ADDENDUM NO. 2
TO THE
DRAWINGS AND SPECIFICATIONS
FOR THE
SOUTH WALNUT STREETScape ANS STORMWATER IMPROVEMENTS PROJECT
PW2012-10

ISSUED FROM: CITY HALL AT THE SHOWERS BUILDING
Post Office Box 100
401 North Morton Street
Bloomington, Indiana 47404

ISSUE DATE: January 9, 2012

Sheet No. 33
 Drawing No. PJ3

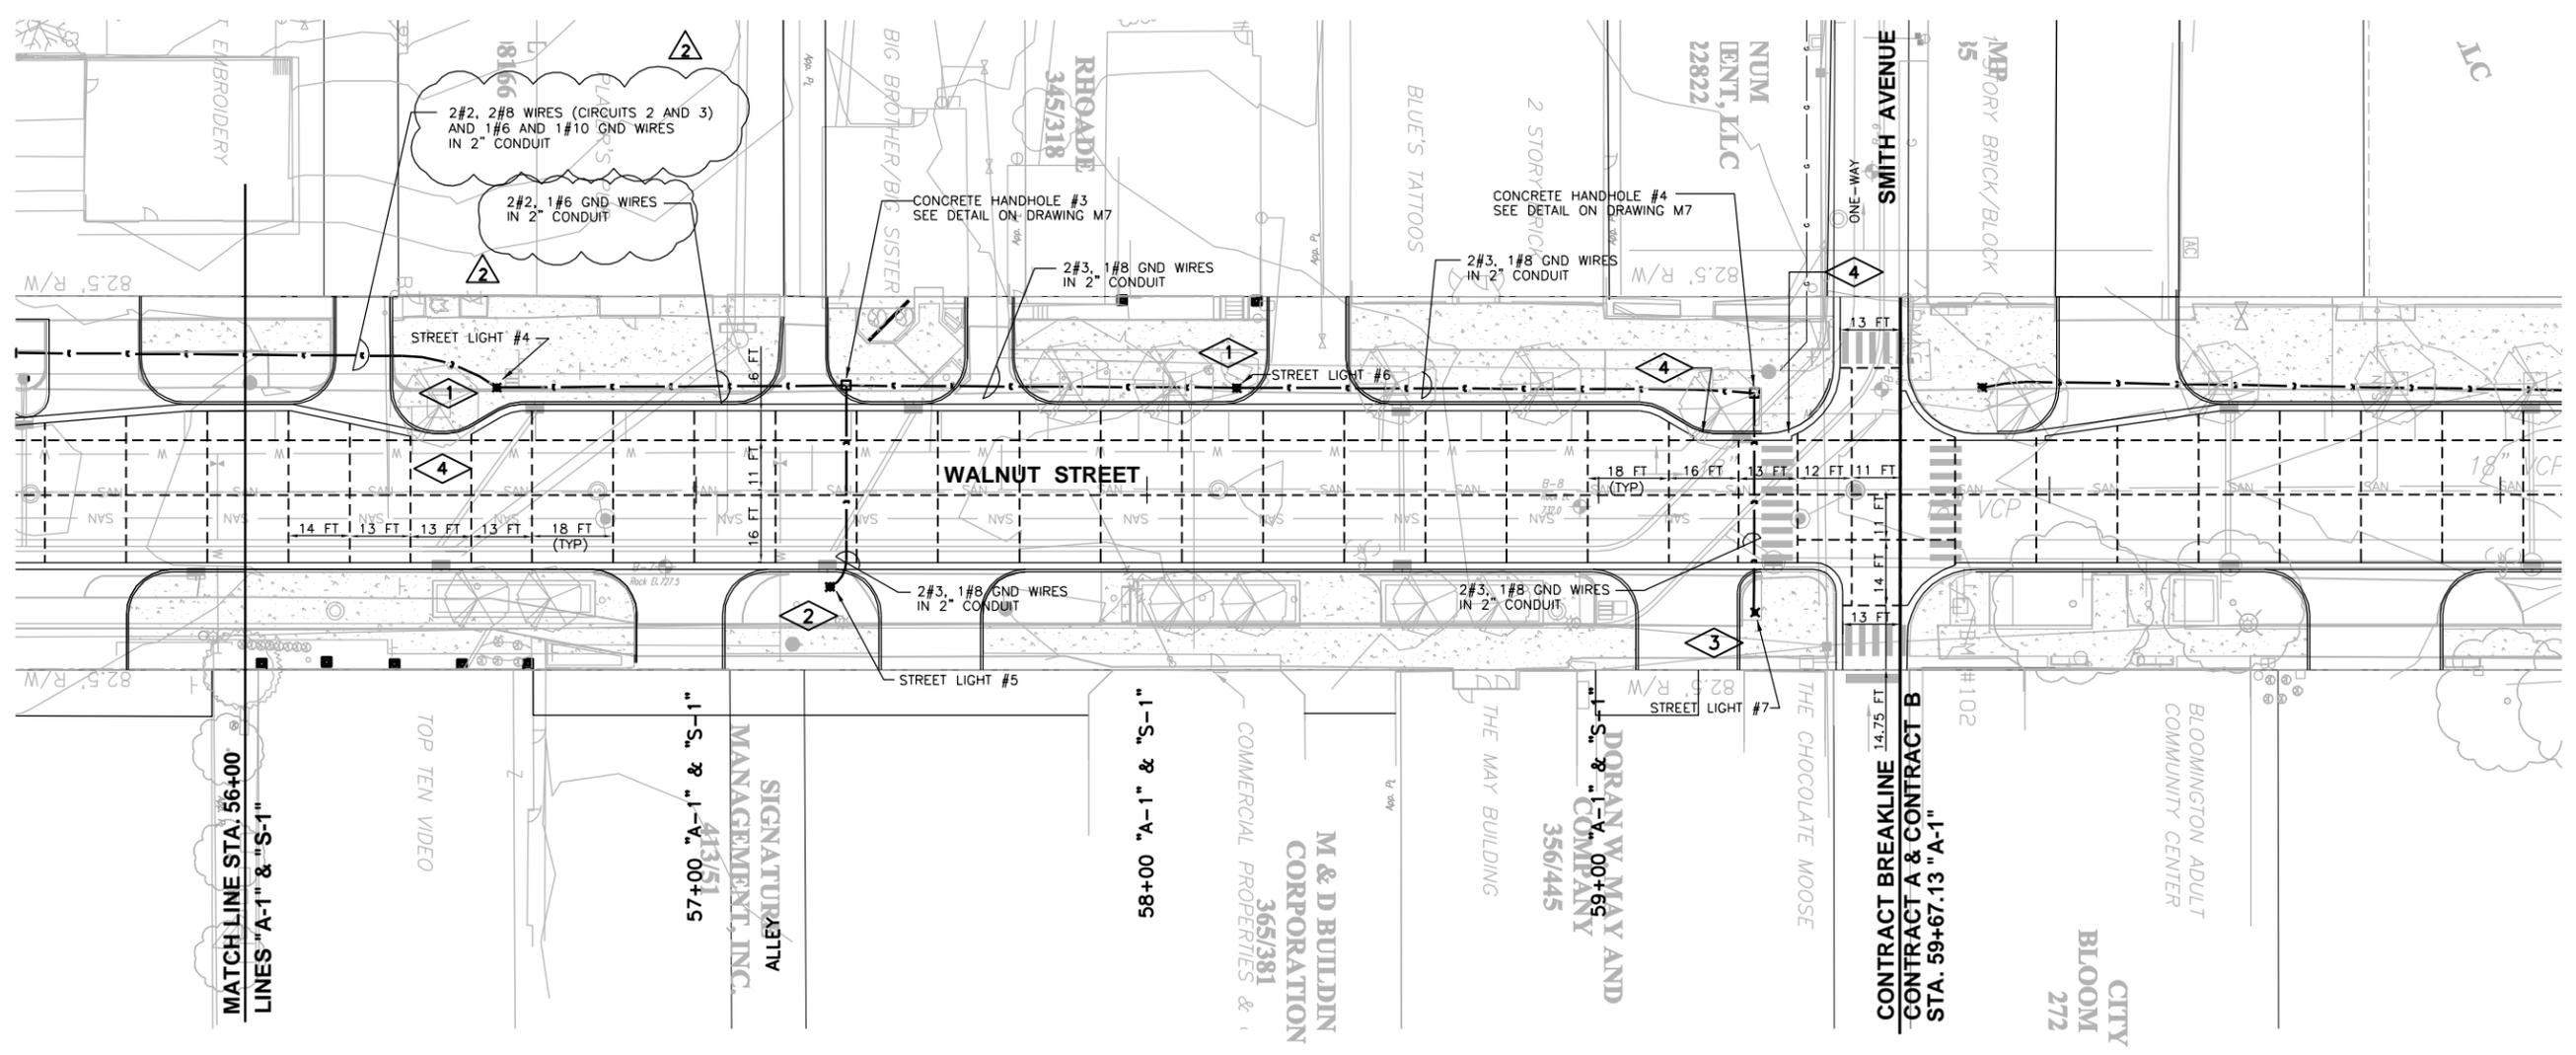
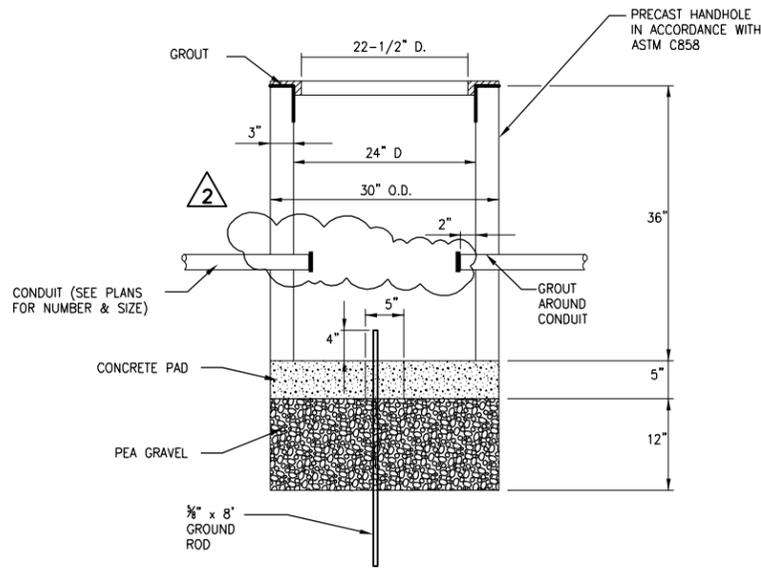
8. Sheet 32, Drawing PJ2 is deleted and a revised Sheet 32 is attached
9. Sheet 33, Drawing PJ3 is deleted and a revised Sheet 33 is attached
10. Sheet 37, Drawing M4. The Contractor will install the irrigation system as shown on the plans, except for the Quick Coupler Valve and Valve Box. The Contractor will install the irrigation lines into the raised planters as shown and cap line in place inside planter box. Suitable soil shall be placed in the planter boxes up to a level 2 feet below the top of the box.

1. STREET LIGHT TO BE MOUNTED ON STANDARD POLE BASE USING STANDARD BASE BOLT PATTERN. REFER TO DETAIL ON DWG M7.
2. STREET LIGHT TO BE MOUNTED ON MODIFIED POLE BASE FOR INSTALLATION OVER BOX CULVERT SECTION. ANCHOR BOLTS TO BE DRILLED INTO CULVERT TOP USING EXPANSION BOLTS AND STANDARD BASE BOLT PATTERN. REFER TO DETAIL ON DWG M7.
3. STREET LIGHT TO BE MOUNTED ON STANDARD POLE BASE USING STANDARD BASE BOLT PATTERN. REFER TO DETAIL ON DWG M7. CONSULT WITH ENGINEER FOR FINAL LOCATION OF THIS LIGHT DUE TO LIMITED AVAILABLE SPACE FOR INSTALLATION AND OVERHEAD LINES.
4. WIDEN CURB GUTTER SECTION APPROXIMATELY 1 FOOT TO MATCH PAVEMENT JOINT PATTERN

CITY OF BLOOMINGTON
 JORDAN RIVER AND LOWER SPANKERS STORM CULVERT
 RECONSTRUCTION AND STREETSCAPE - CONTRACT A
 BLOOMINGTON, INDIANA
 MISCELLANEOUS DETAILS
 ELECTRICAL CONNECTIONS

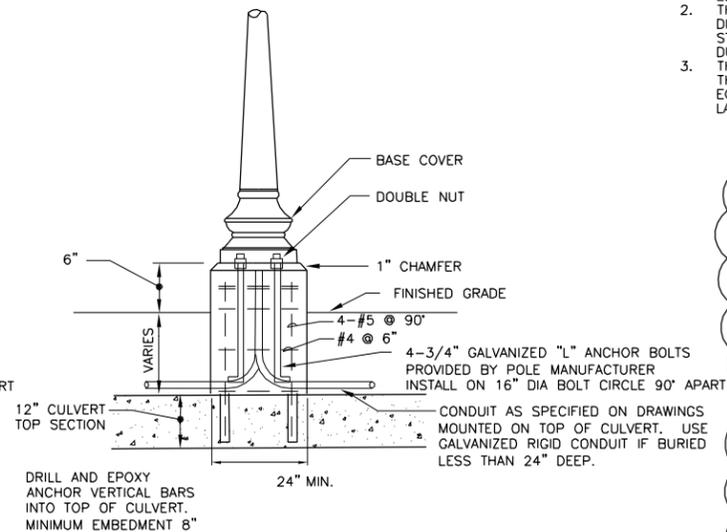
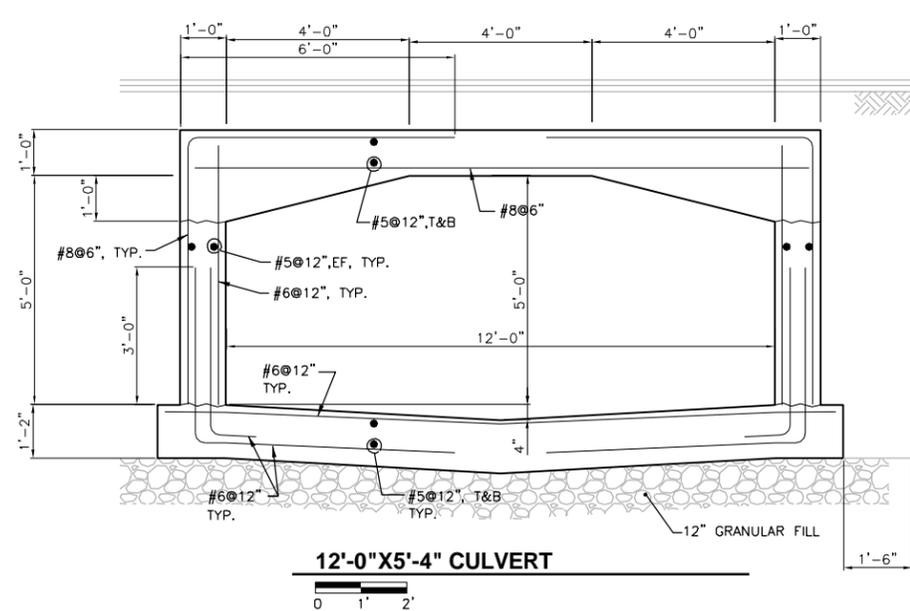
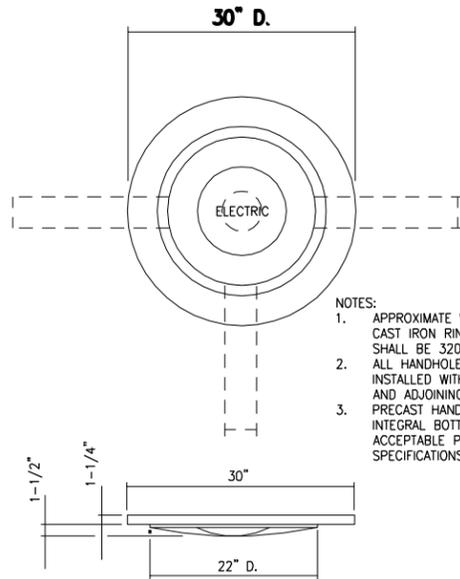
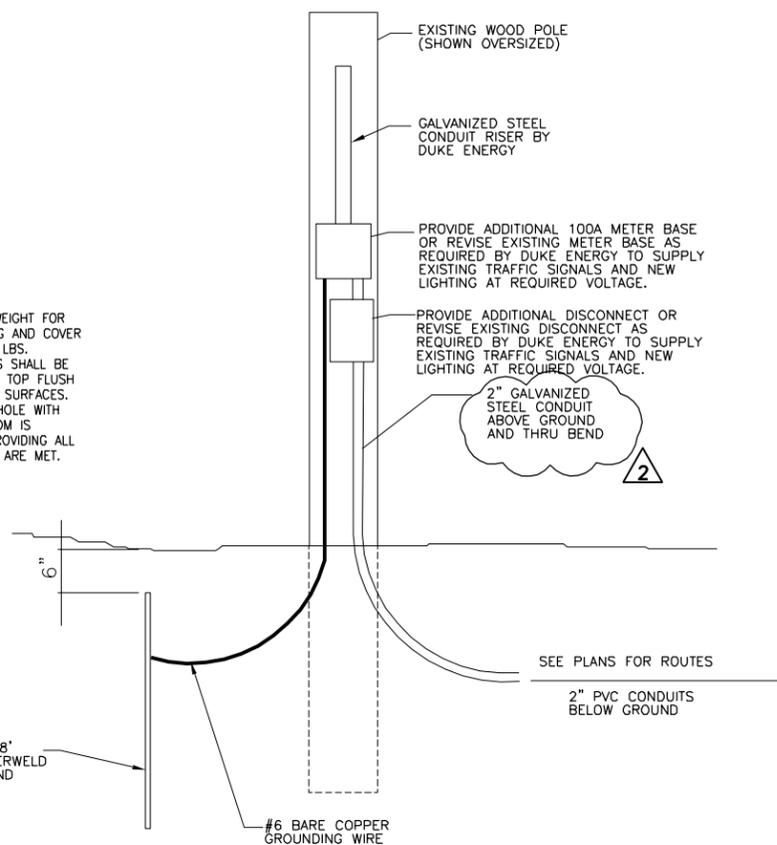
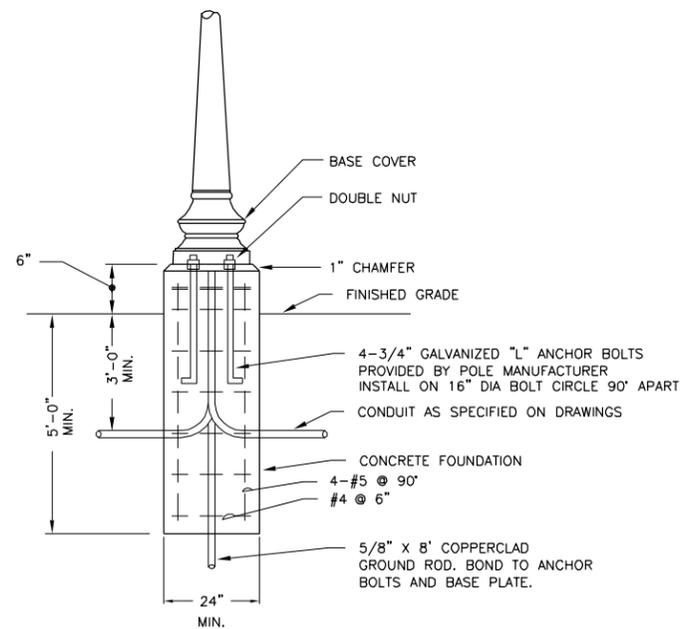
11. Sheet 40, Drawing M7 is deleted and a revised Sheet 40 is attached
12. Sheet 41, Drawing S1 is deleted and a revised Sheet 41 is attached

1. EXTEND "L" ANCHORS TO TOP OF CULVERT IF CULVERT TO TOP OF BASE IS LESS THAN ANCHOR LENGTH. IF ANCHORS LENGTH IS LONG ENOUGH TO EXTEND THROUGH TOP OF CULVERT SLAB INSERT ANCHORS THROUGH SLAB SO "L" HOOKS ENGAGE BOTTOM OF TOP SLAB AND COVER HOOKS WITH EPOXY TO PROTECT FROM CORROSION. TWO OF THE DRILLED AND EPOXYED #5 BARS MAY BE ELIMINATED IF ANCHORS EXTEND THROUGH SLAB.
2. INSTALL 3/8 X 8 FT COPPERCLAD GROUND ROD AT EDGE OF CULVERT AND CONNECT TO ANCHOR BOLTS AND BASE PLATE WITH #8 INSULATED COPPER WIRE.
